Technical Bulletin

Technical Bulletin Unique Identifier	DOC2848327
Title	Service Note for the impact of removal of ICC facility bypass valve in 1.5T SIGNA Prime & 1.5T SIGNA Victor/ Star Air/ Aviator Air
Subject	Service Note for the impact of removal of ICC facility bypass valve in 1.5T SIGNA Prime & 1.5T SIGNA Victor/ Star Air/ Aviator Air
Applicability (e.g., affected product, process)	1.5T SIGNA Victor 1.5T SIGNA Aviator Air 1.5T SIGNA Star Air 1.5T SIGNA Prime
Date	07-Aug-2023
Relevant Product Business (select one)	☒ Imaging ☐ Patient Care Solutions ☐ Ultrasound ☐ Other: _____
Originating Modality	MR
Details	To avoid the problem of cooling water backflow, Option 1: Switch facility water to cooled cryogenic compressor as Emergency Backup Water Supply method is now removed.
Tracking Number	ECR2356897
Affected Service Publications	1.5T SIGNA Victor/Star Air/Aviator Air Service Manual Class A: 5957356-8EN Rev.1; Class C: 5957355-8EN Rev.1; Class M: 5957347-8EN Rev.1 1.5T SIGNA Prime Service Manual Class A: 5807565-2EN Rev.4; Class C: 5807569-2EN Rev.4; Class M: 5807568-2EN Rev.3

Figure 1. Removed Valve BV11 & BV12

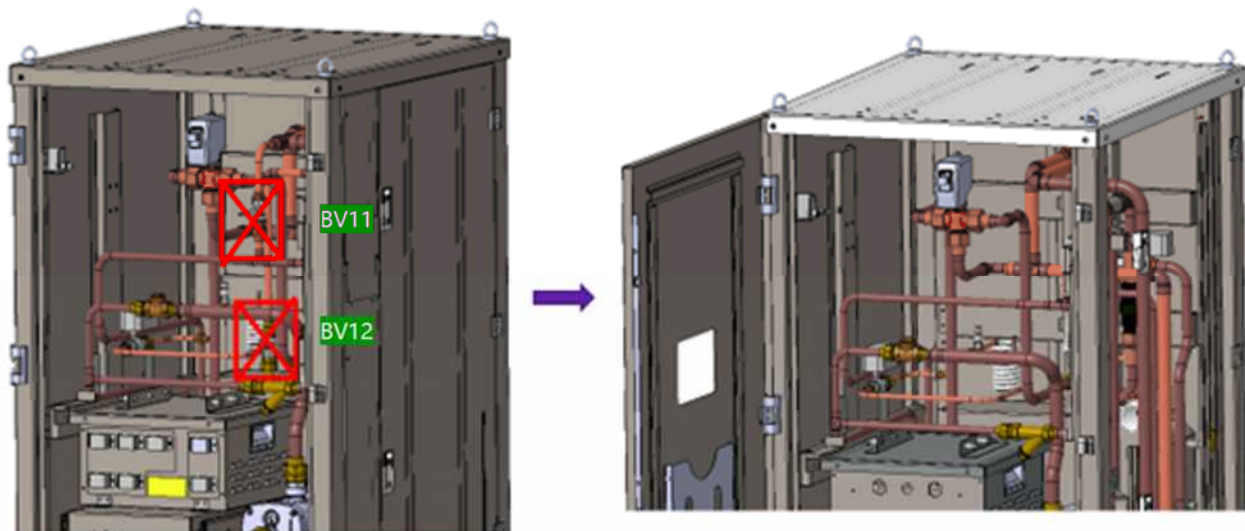
While applying **Option 1: Switch facility water to cooled cryogenic compressor** for Emergency Backup Water Supply it may cause the cooling water pour back.

To avoid this problem, **remove Option 1: Switch facility water to cooled cryogenic compressor** as Emergency Backup Water Supply method, keep **Option2: Switch city water to cooled cryogen compressor** as the only Emergency Backup Water Supply backup method for ICC cabinet (5842254).

The design of the latest ICC cabinet (5842254 Rev.3) removed the 2 water valves BV11 and BV12, and the rest sides of them have been blocked.

Figure 2. Removed Valve BV11 & BV12

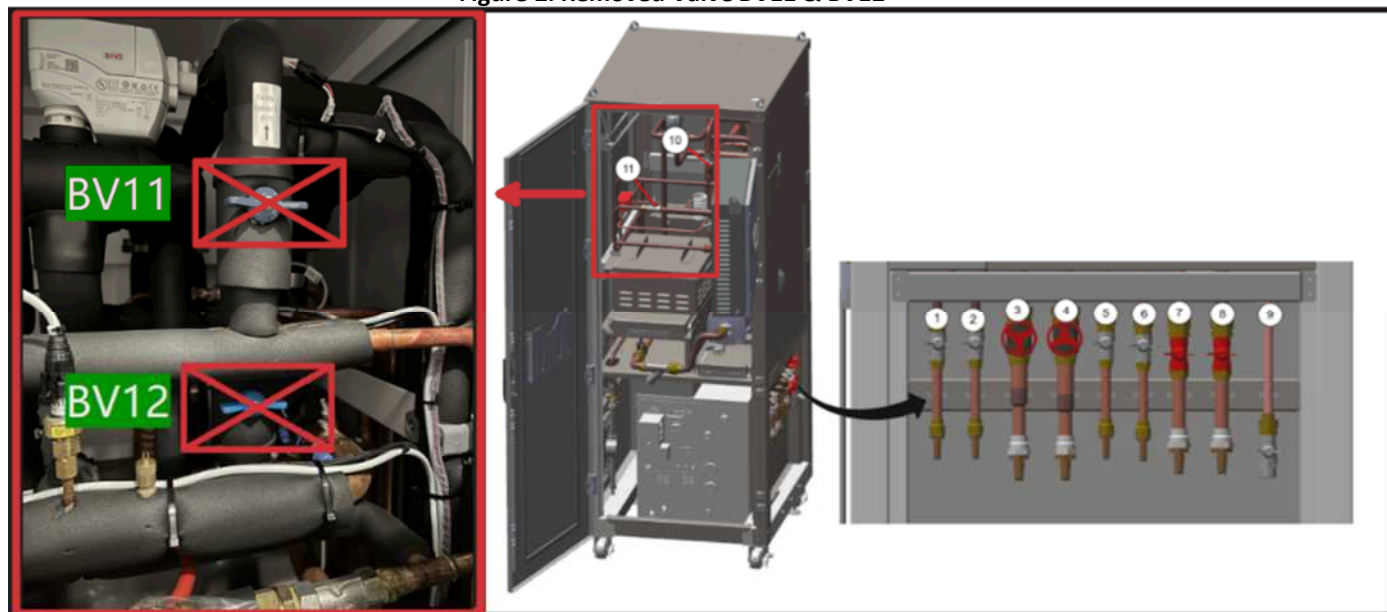
Removed Option 1: Switch facility water to cooled cryogen compressor.

Option 2: Switch city water to cooled cryogen compressor is the **only way as F50-SH Emergency Backup.**

For the ICC cabinet (5842254 Rev.3), it is no longer necessary to check whether BV11 & BV12 valves are closed.

Figure 3. Removed Label in the latest ICC cabinet

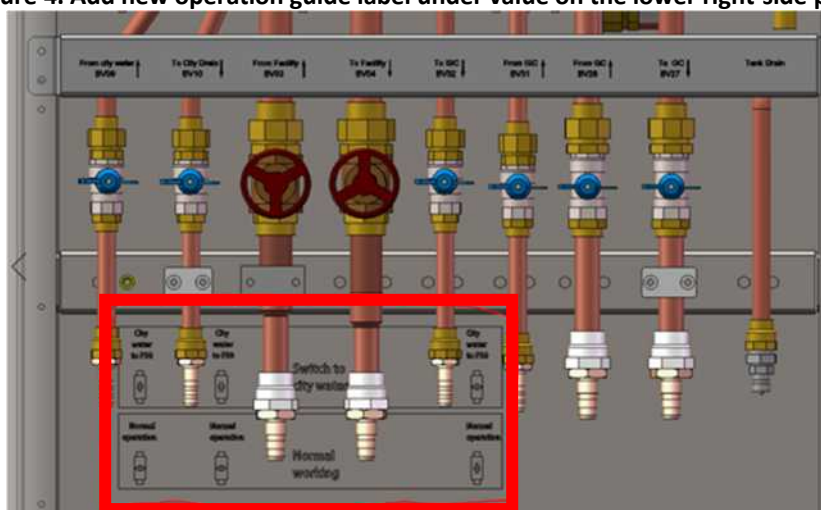
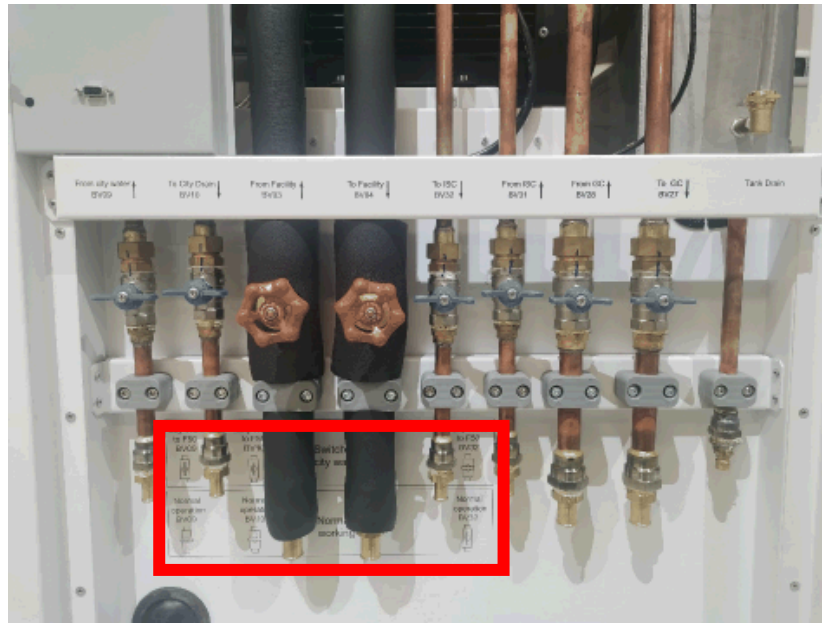
The latest ICC cabinet (5842254 Rev.3) also removed the Emergency value label description on the lower right-side panel of the ICC cabinet and behind the ICC control box.
